DEVELOPMENT REVIEW BOARD MEETING

**DEVELOPMENT REVIEW BOARD
RESOLUTION NO. 404**

Exhibit A1
Staff Report
Wilsonville Planning Division
Wilsonville Industrial Yard

Hearing Date:	July 25, 2022
Date of Report:	July 18, 2022
Application Nos.:	DB22-0001 Wilsonville Industrial Yard <ul style="list-style-type: none">- Zone Map Amendment (ZONE22-0001)- Stage 1 Preliminary Plan (STG122-0001)- Stage 2 Final Plan (STG222-0001)- Site Design Review (SDR22-0001)
Request/Summary:	The requests before the Development Review Board include a Zone Map Amendment, Stage 1 Preliminary Plan, Stage 2 Final Plan, and Site Design Review for a 54,664-square-foot industrial yard with an existing house and site improvements.
Location:	28505 and 28635 SW Boones Ferry Road. The property is specifically known as Tax Lots 800 and 900, Section 14A, Township 3 South, Range 1 West, Willamette Meridian, City of Wilsonville, Clackamas County, Oregon
Owner/Applicant:	Davidsons Boones Ferry Industrial LLC (Contact: William "Gregg" Davidson)
Applicant's Representative:	AAI Engineering (Contact: Beth Zauner)

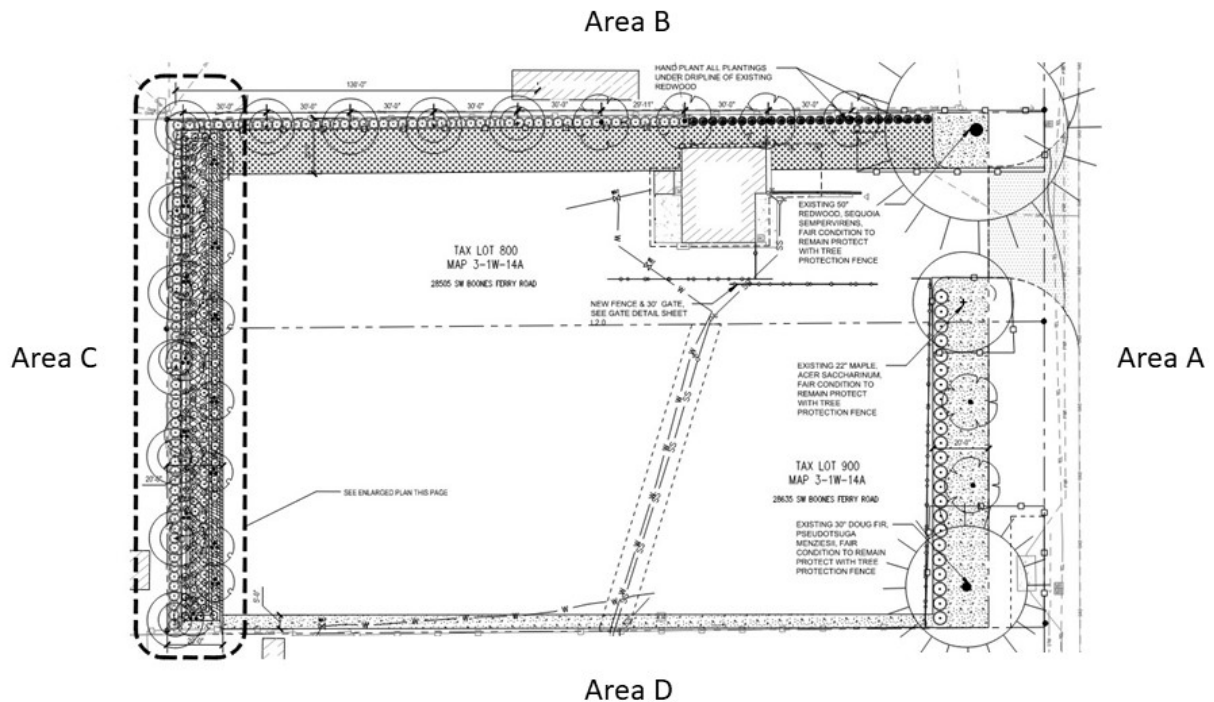
C42. As shown on Sheets L1.0 and L2.0 (Exhibit B2), materials required to meet landscaping standards are provided as follows:

Area Description:	East and south sides of site
Landscaping Standard:	High Screen
Comments on Intent:	Provides visual separation and sight-obscuring screen of outdoor storage yard from adjacent properties and public right-of-way
Required Materials:	Fully cover, 6-foot hedge 95% opaque year round, trees every 30 feet or as required to provide canopy over landscape area.
Materials Provided:	<p>Area A – East side along SW Boones Ferry Road: Euonymus hedge and native meadow mix grass in front (on street side) of 6-foot chain link fence with privacy slats provides screening. Tree canopy includes three (3) preserved trees (30-inch d.b.h. Douglas-fir, 22-inch d.b.h. maple, 50-inch d.b.h. sequoia) and two (2) red maple trees.</p> <p>Area D – South side along adjacent property: Native meadow mix grass in front (inside property) of six (6)-foot fence with privacy slats. Seven (7) trees, but not shrubs or groundcover, were planted along the south boundary of the property as required mitigation for the retroactive tree removal permit (TR21-0002); however, no hedge or trees are shown on landscape plan in this area. The southwest corner of Area D is adjacent to the mobile home park and subject to the requirements of the SB Overlay Zone. Conditions of Approval ensure that the south</p>

Area Description:	North and west sides of site along property line shared with Walnut Mobile Home Park
Landscaping Standard:	High Screen or High Wall required– SB Overlay Zone applies
Comments on Intent:	Screening and buffering required between development and residential use to north, west, and southwest
Required Materials:	High Screen: Fully cover, 6-foot hedge 95% opaque year round, trees every 30 feet or as required to provide canopy over landscape area. High Wall: 6-foot masonry wall, trees every 30 feet or as required to provide canopy over landscape area. SB Overlay Zone: 20-foot buffer area with High Screen or 10-foot buffer area with High Wall.
Materials Provided:	<p>Area B – North side adjacent to mobile home park: 20-foot-wide buffer area provided between south property line of mobile home park and gravel area of industrial yard. Six (6)-foot chain link fence with privacy slats on north side of buffer. Arborvitae hedge with kinnikinnick groundcover on south side of fence (inside property). Tree canopy includes nine (9) red maples roughly 30 feet on center.</p> <p>Area C – West side adjacent to mobile home park: 20-foot-wide buffer area provided between east property line of mobile home park and gravel area of industrial yard. Six (6)-foot chain link fence with privacy slats on west side of buffer. Arborvitae hedge and stormwater facility with native plantings on east side of fence (inside property). Tree canopy includes six (6) red maples roughly 30 feet on center.</p>
